# **Critique by the Committee to Bridge the Gap of the Navy's Draft Five-Year Review Hunters Point Naval Shipyard**

7 September 2018

Asphalt at HPNS made out of HPNS sandblast grit

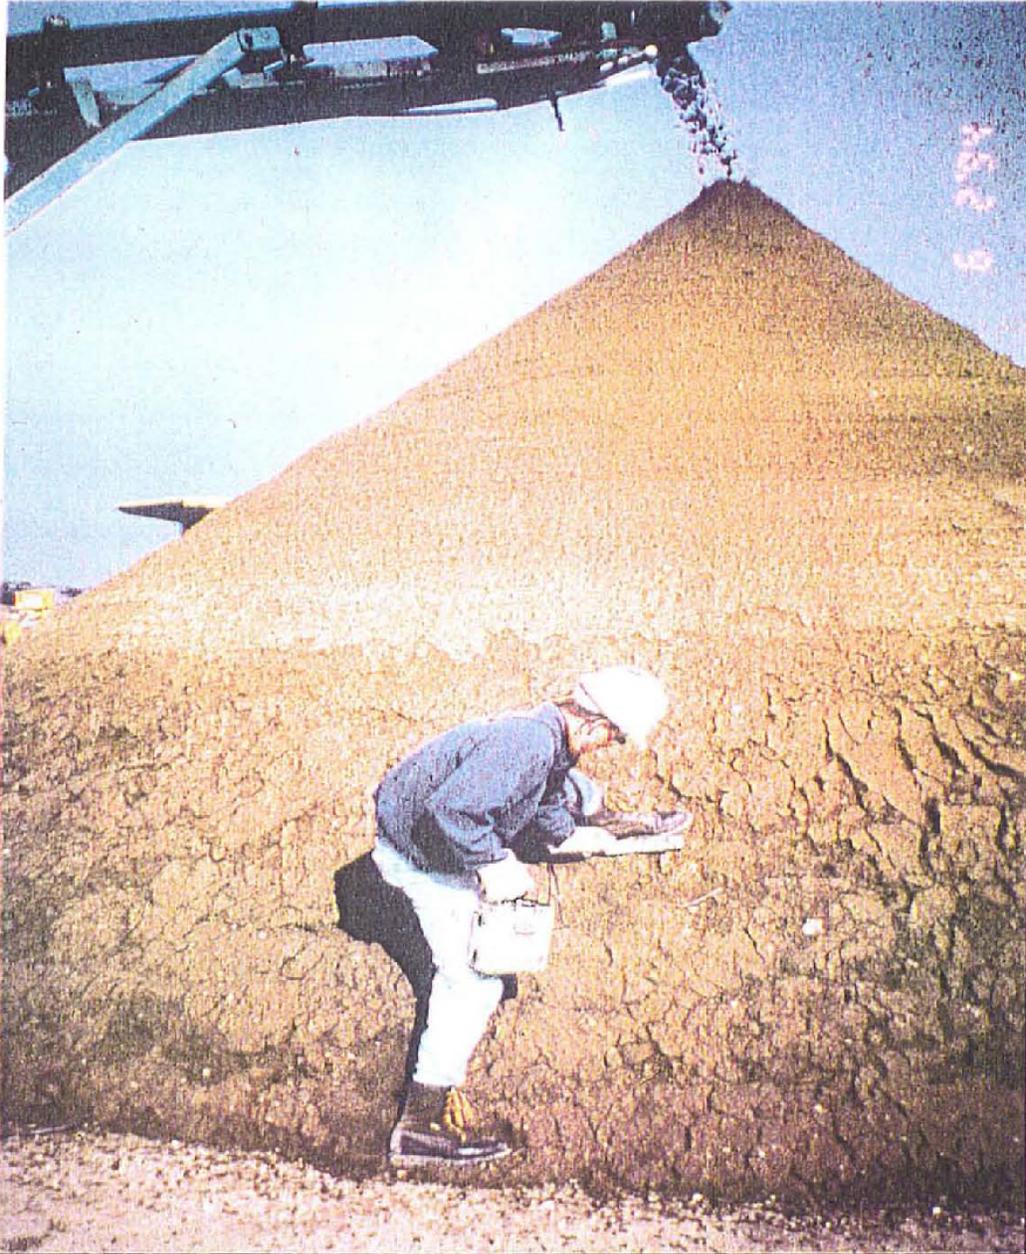
Sandblast grit, from sandblasting scores of contaminated ships from the nuclear testing in the Pacific to decontaminate them, is one of the primary mechanisms of pollution at HPNS. However, there remain questions regarding how much sandblast grit was produced at HPNS, how much has been questionably recycled, how much remains on site and how much placed elsewhere offsite, and the environmental impacts that can follow. This Review does not examine those questions. The only mention of Sandblast grit recycling in the Five-Year Review is the following statement, “[b]etween 1991 and 1995, the Navy collected nearly 5,000 tons of sandblast grit from multiple areas at HPNS. The material was sent to an asphalt plant for reuse in an asphalt mix.”(page 3-1). This brief utterance fails to disclose that some of the asphalt was brought back to the site to be used to produce and install asphalt with the contaminated grit.

Other documents indicate that large amounts of additional potentially contaminated grit was sent to the Central Valley to be made into asphalt for use there.<sup>6</sup> The method for determining whether there was radioactivity in the sandblast grit (and subsequent asphalt) appears primitive at best – a handheld Geiger-counter type device that is unlikely to be able to detect radionuclides at the level of concern.

There is no consideration in the Five-Year Review of the protectiveness or danger of either the HPNS asphalt or Central Valley asphalt made with potentially contaminated sandblast grit.
